WSX-C18 – Bioresources and the Industrial Emissions Directive (IED)

Response to
Ofwat's PR24 draft
determination

Representation reference: **WSX-C18**

Representation title: **Bioresources and the Industrial Emissions Directive (IED)**

Figure 1 – Range of efficiency scores for a set of draft determination models

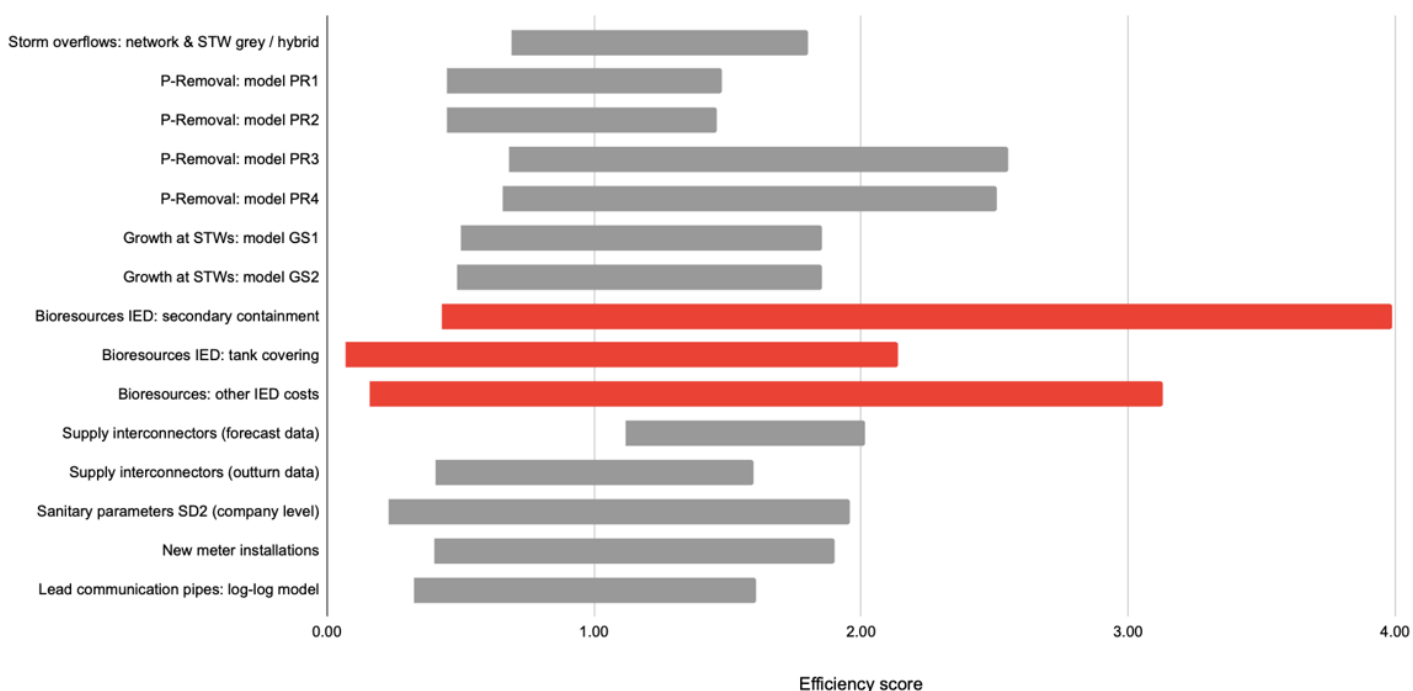
Figure 1 compares the range of efficiency scores across different enhancement models. Where econometric modelling was done at the level of individual schemes, we used the efficiency ratios reported at the company level (i.e. reflecting modelling costs aggregated across each company's schemes). The range for the three IED categories is shown in red.

As illustrated above, the ranges of efficiency scores for the three IED categories are notably higher than for the other enhancement benchmarking models presented.

Figure 2 – Standard deviation of efficiency scores for a set of Ofwat draft determination models

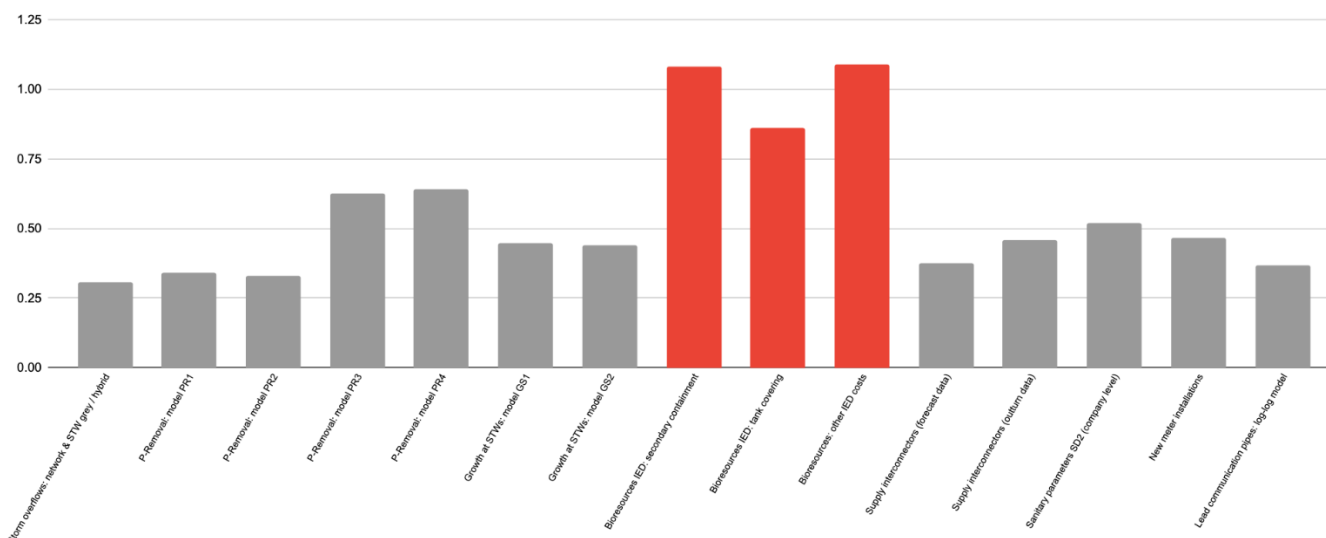
As with efficiency score ranges, the standard deviation of efficiency scores for each of the three categories of IED enhancements used in the draft determination is considerably higher than that for each of the other enhancement models or categories from the chart.

As expected, due to the variety of heterogeneous types of investment (liquor sampling, control and monitoring, permit application and other investments), there is a very large standard deviation seen for the “other IED cost” category using companies’ sludge volumes to normalise these data points. The models for the other two categories of IED costs also show a significant spread of efficiency scores. For instance, the standard deviation of efficiency scores for the secondary containment model is between around 70% and 350% higher than that of the models for enhancements outside of IED.

Figure 3 – Proportion of components of “Other IED costs” across schemes

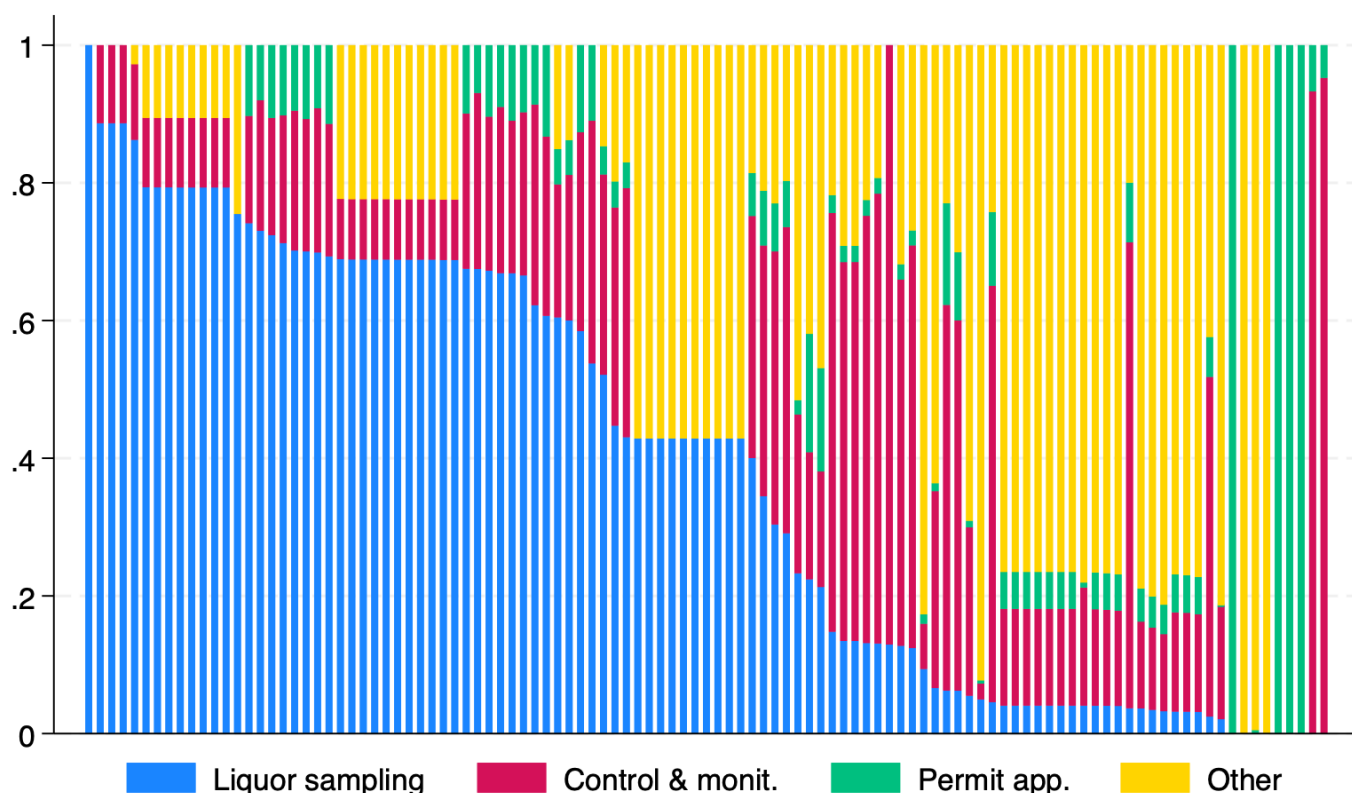
Figure 3 captures this last point. For each scheme within the dataset drawn on in the assessment, the figure shows the proportion of each of the sub-categories of enhancement costs falling within the “Other IED costs” category. It is evident from the chart that there is much variation across schemes.

In light of the above considerations, we do not see the basis for the approach used in benchmarking “Other IED costs”.

Figure 4 – Avonmouth Main BC Area

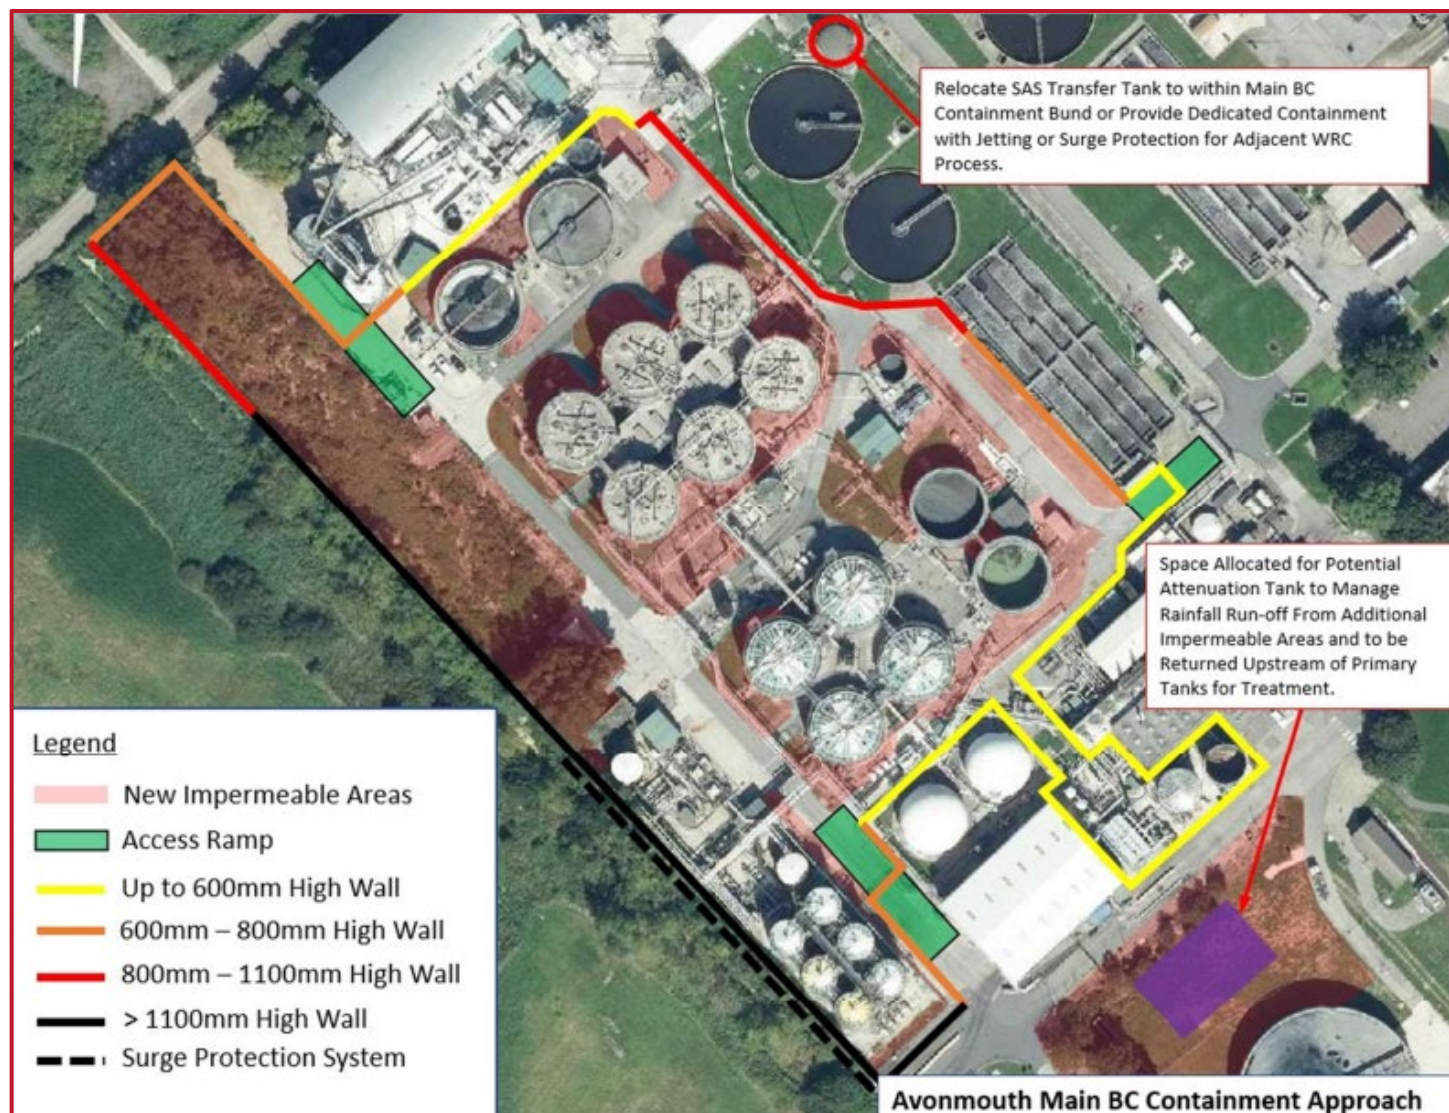
- As explained in our response for Query OFW-OBQ-WSX-204, the height of a section of bund wall for Avonmouth had to be increased to protect a nearby Scheduled Monument from jetting effects in the event of tank failure. This has increased the efficient cost of the secondary containment solution for Avonmouth.

Figure 7 – Berry Hill site-wide perimeter containment

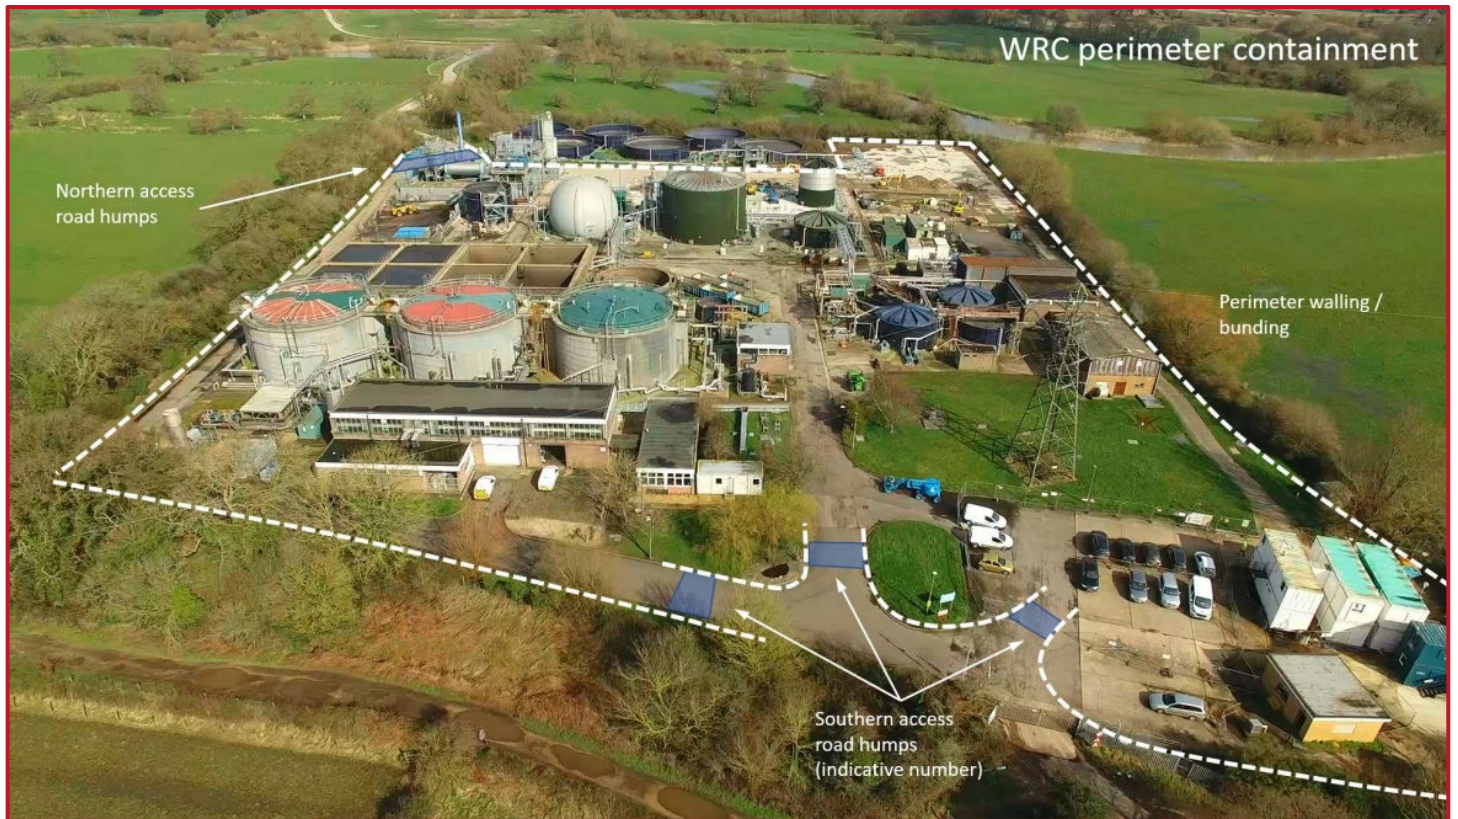
- Other solutions involving bunding individual groups of tanks as opposed to a wider area solution was not deemed to be feasible because of unacceptable required wall heights and the impact on the safe operation and maintenance of these tanks. The proximity of assets such as the primary digesters and secondary digesters to the existing site boundary reinforces the benefit of a perimeter containment solution.
